10 July 2020

Richland Parks and Recreation Building | City of Richland  
WBA Project No. 2619

## ADDENDUM NO. 03

**E0.4**  
DEMOLITION SITE  
PLAN

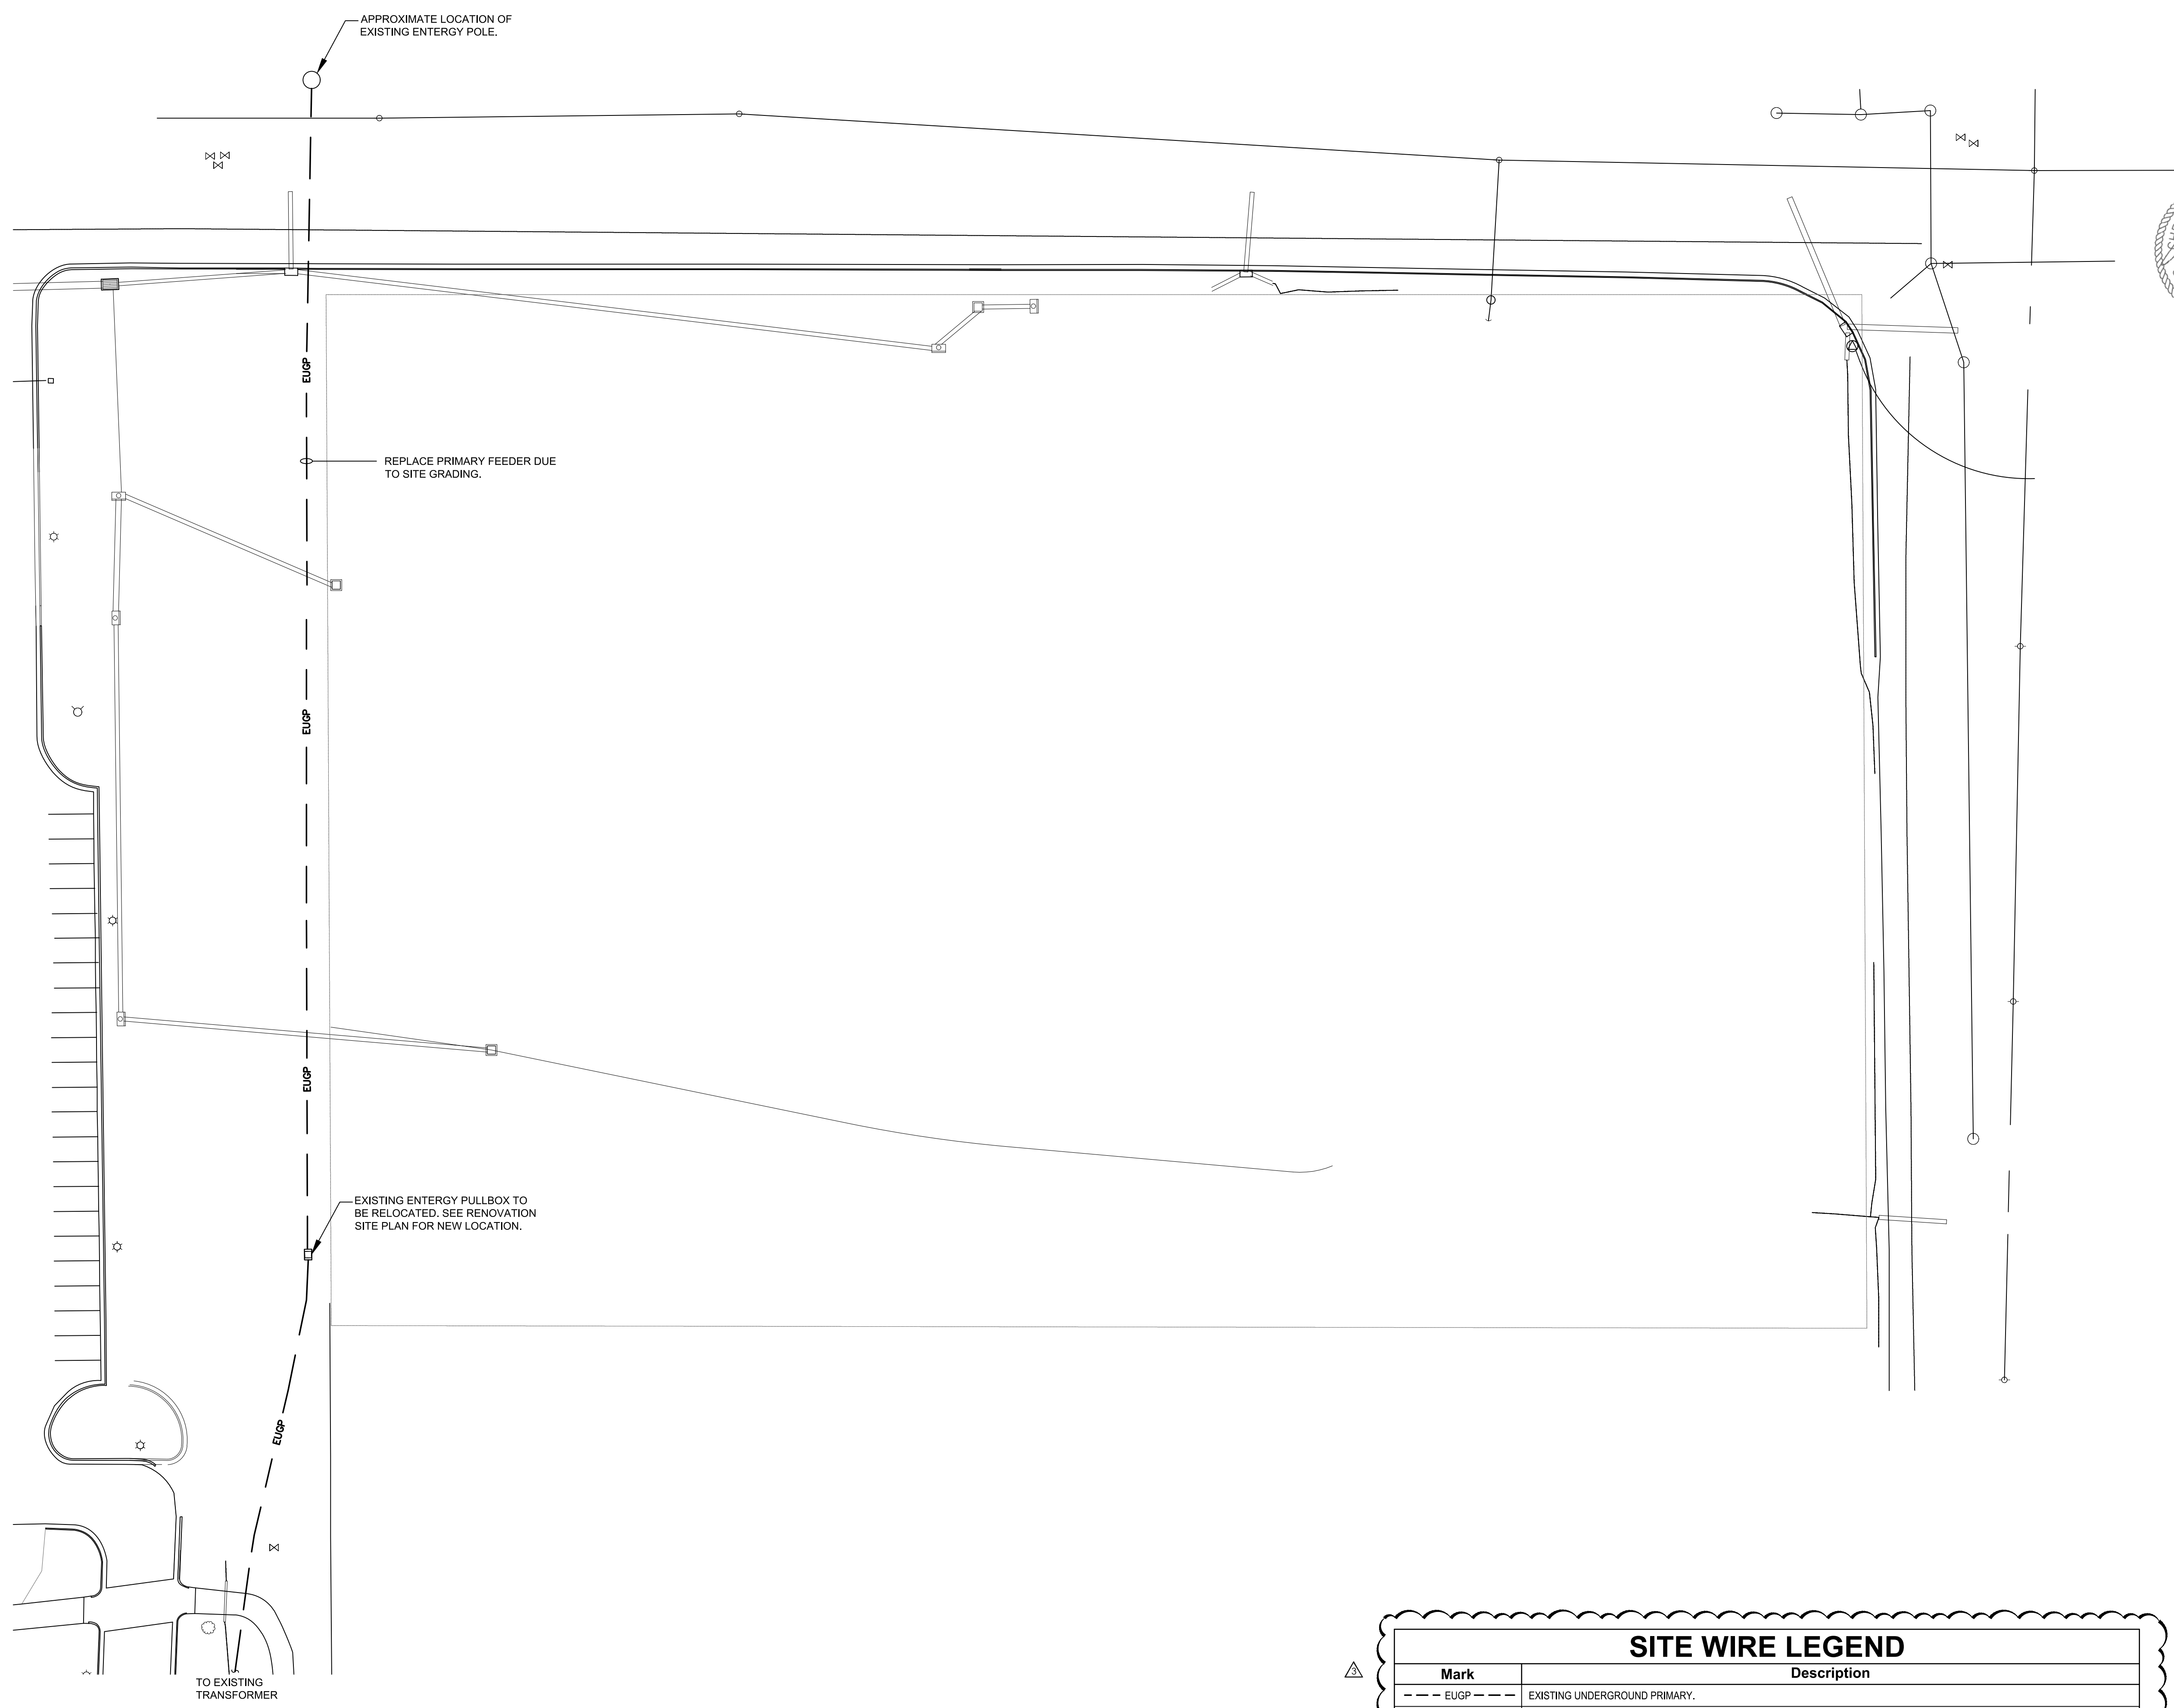
- ITEM NO. 18**      **SHEET E0.4 DEMOLITION SITE PLAN**  
**DELETE** sheet in its entirety and **REPLACE** with enclosed sheet. **ADD** site wire legend.

**E0.5**  
ELECTRICAL SITE  
PLAN

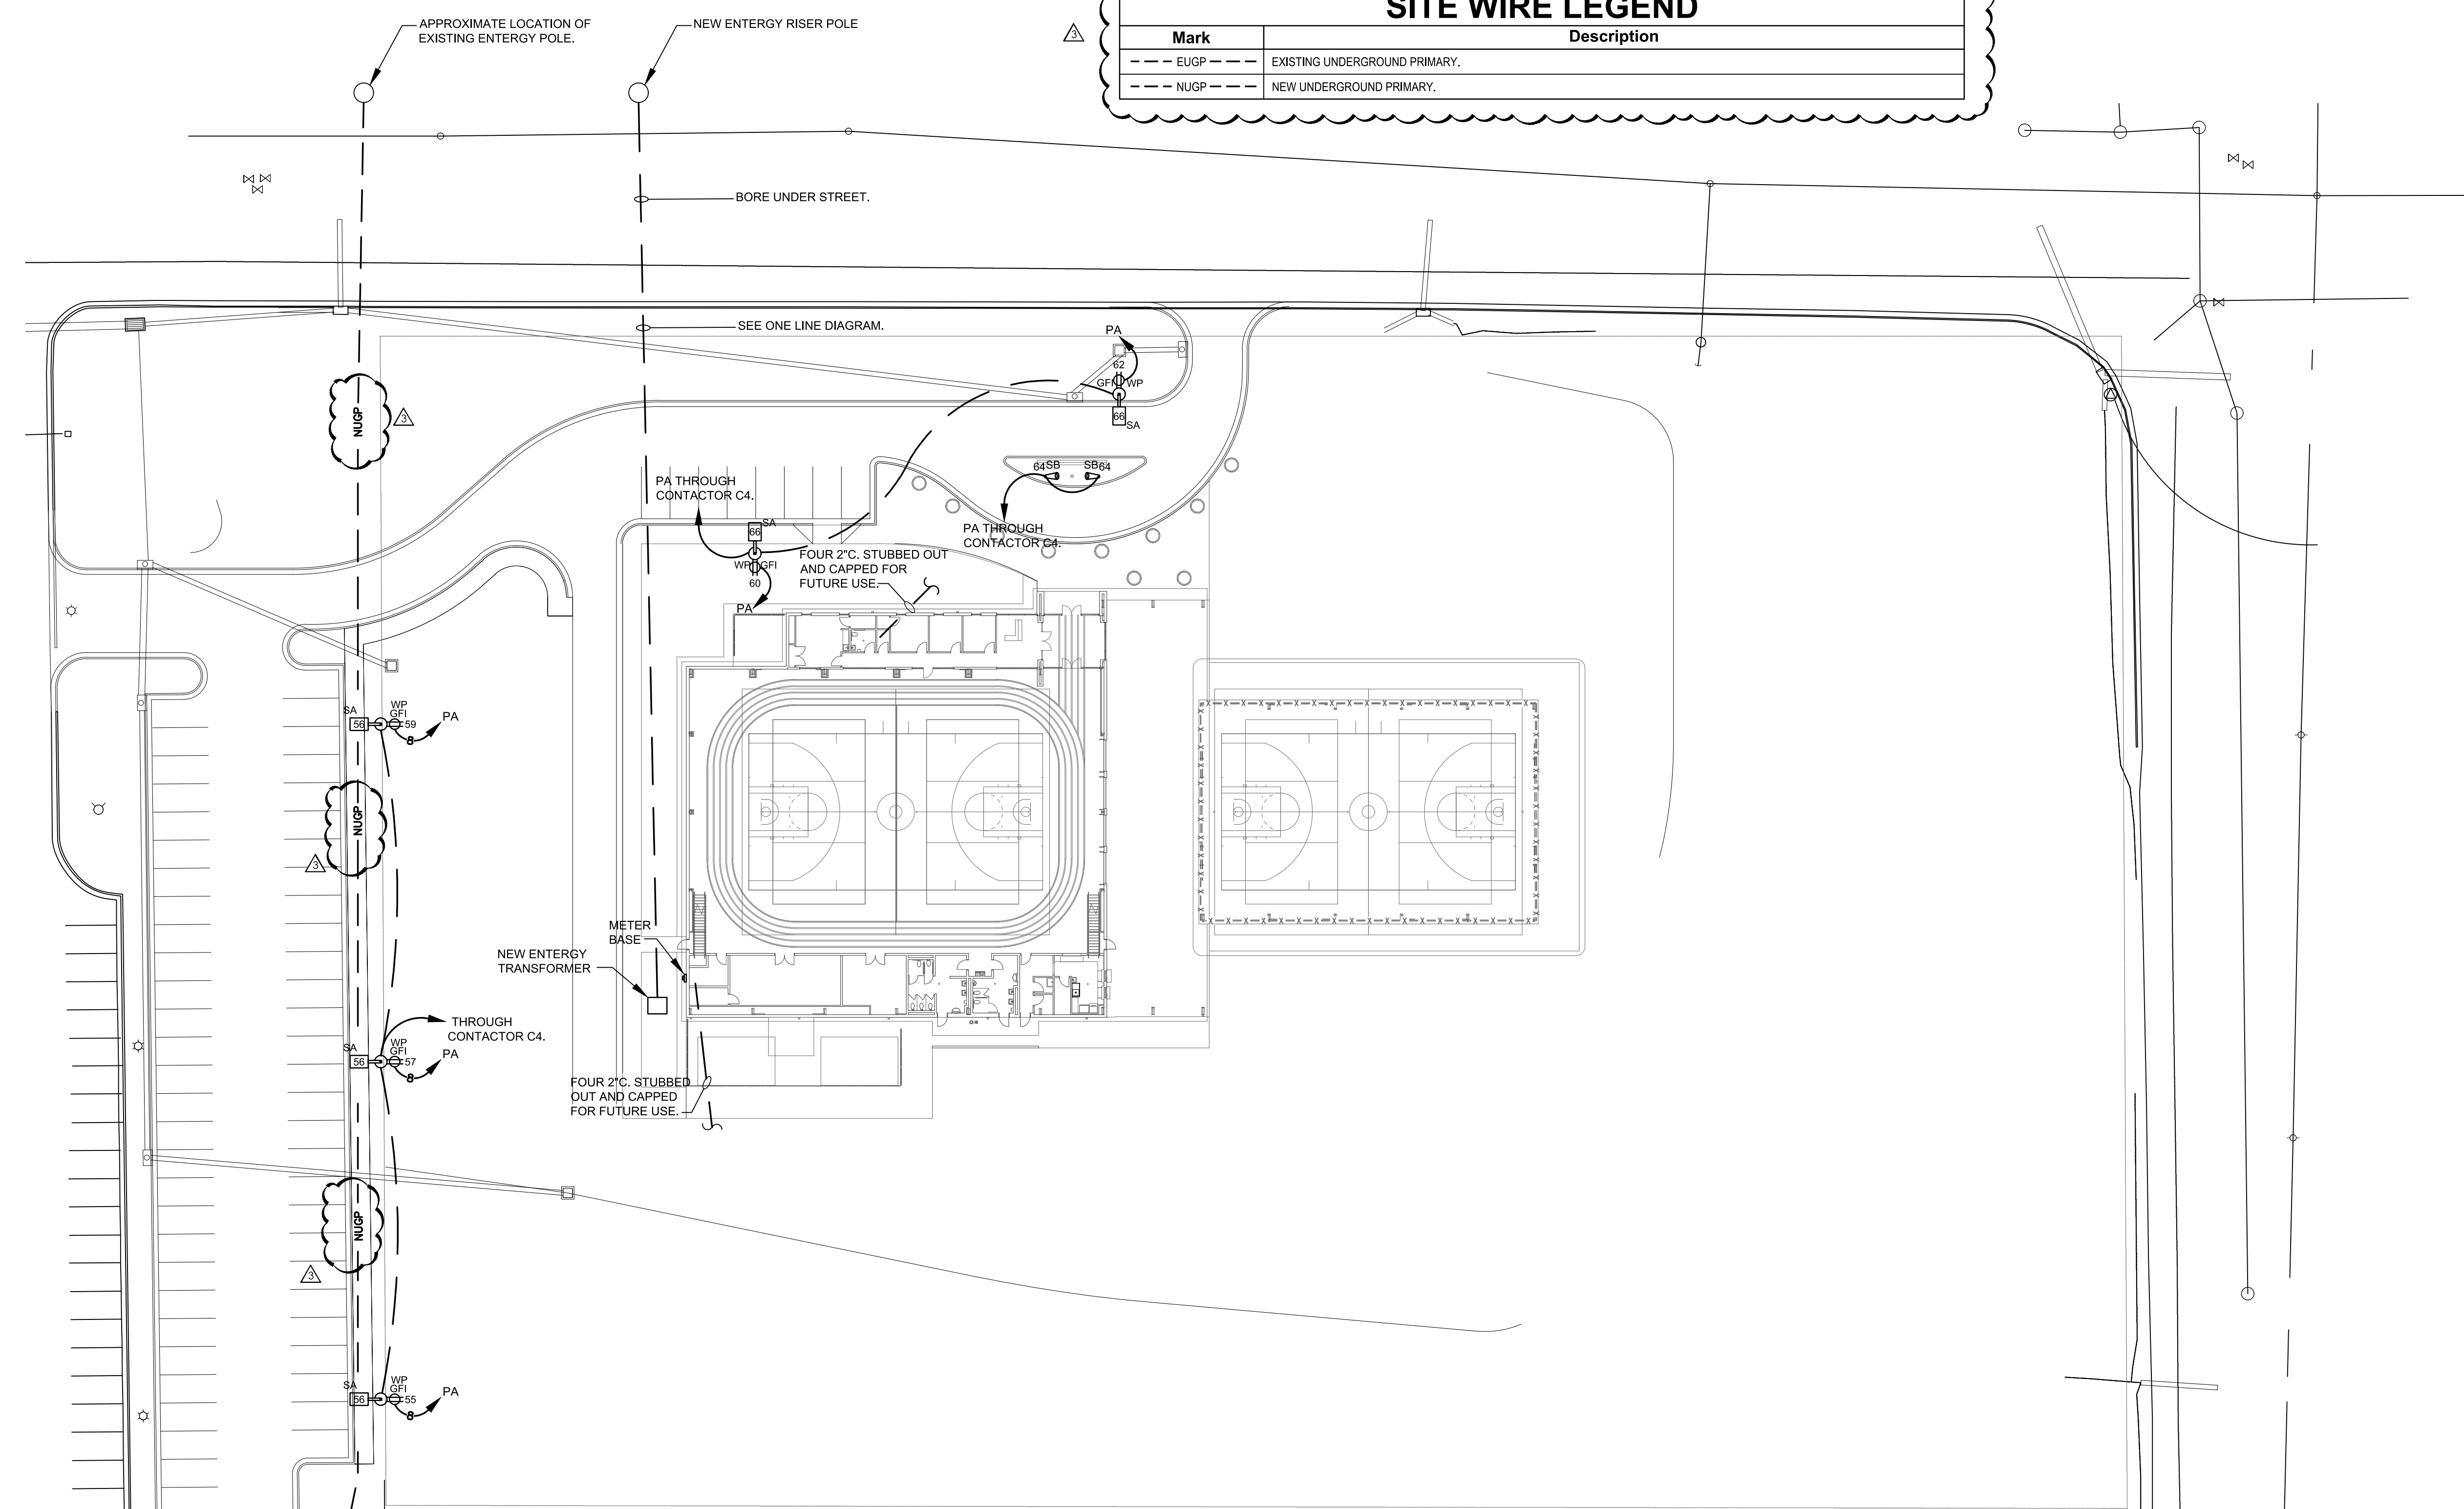
- ITEM NO. 19**      **SHEET E0.5 ELECTRICAL SITE PLAN**  
**DELETE** sheet in its entirety and **REPLACE** with enclosed sheet. **ADD** site wire legend.

**E3.1**  
MECHANICAL/AUXILIARY PLAN - PART B

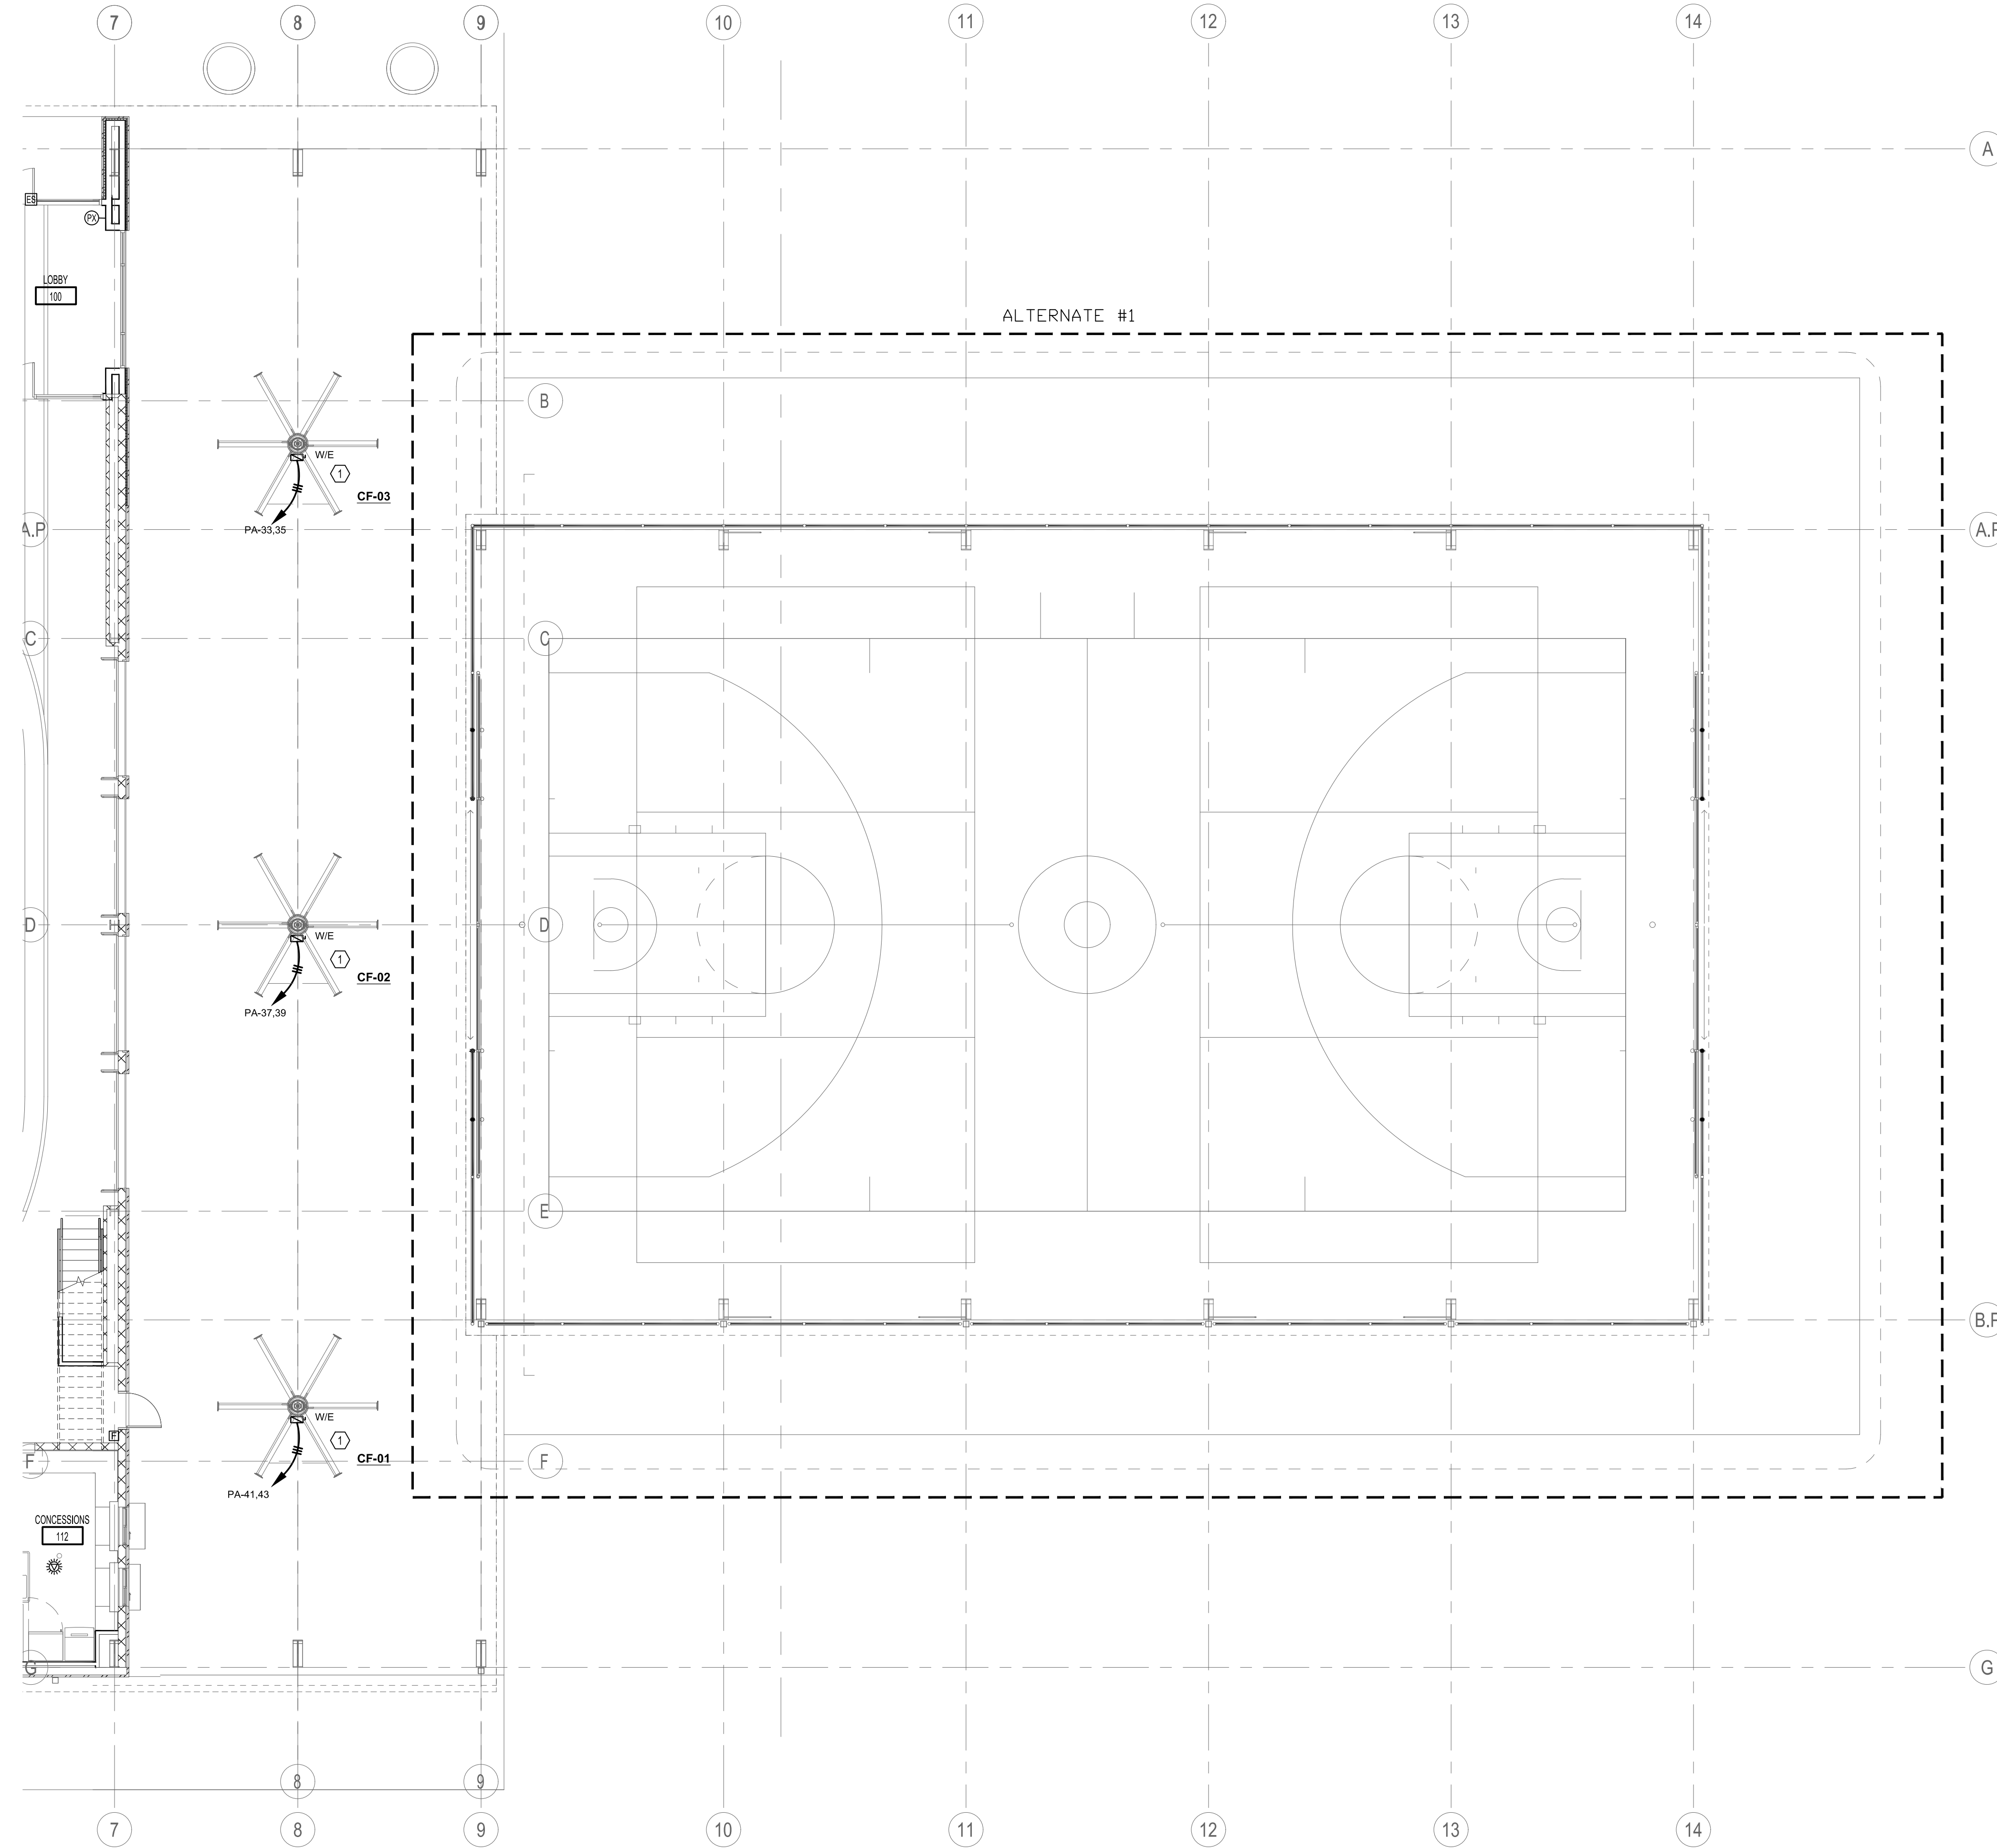
- ITEM NO. 20**      **SHEET E3.1 MECHANICAL/AUXILIARY PLAN – PART B**  
**DELETE** sheet in its entirety and **REPLACE** with enclosed sheet. **REVISE** master keyed notes.
